Exterior Door Switch Sealing

Bulletin type: Aftersales
Reference number: AFT.006.2021
Campaign reference: N/A
Attention: Retailer Aftersales Managers, Retailer Service Managers, Retailer Service Advisors, Retailer Technicians, Retailer Parts Managers,
Affected vehicles: 540C, 570S, 570GT, 600LT, 620R
Situation: Additional sealing process required
Procedure: Seal switch 13A4087CP before replacement
Date: 22nd February 2021

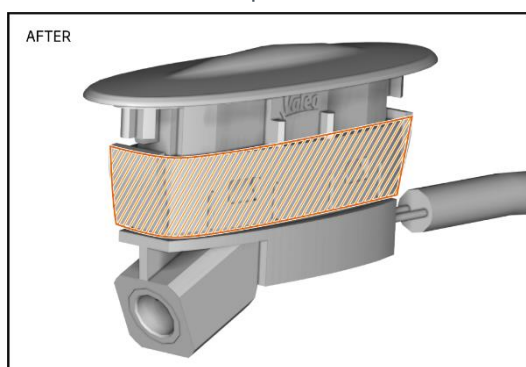
- 1) Using DP604NS adhesive cover the exposed gaps in the switch as shown in the image below. Apply to both sides of switch

- 2) Using a suitable tool, smooth the adhesive to ensure complete coverage around the switch. No gaps in the sealant should be present in this area

- 3) Allow the adhesive to dry for a minimum of 20 minutes before fitting switch to the vehicle
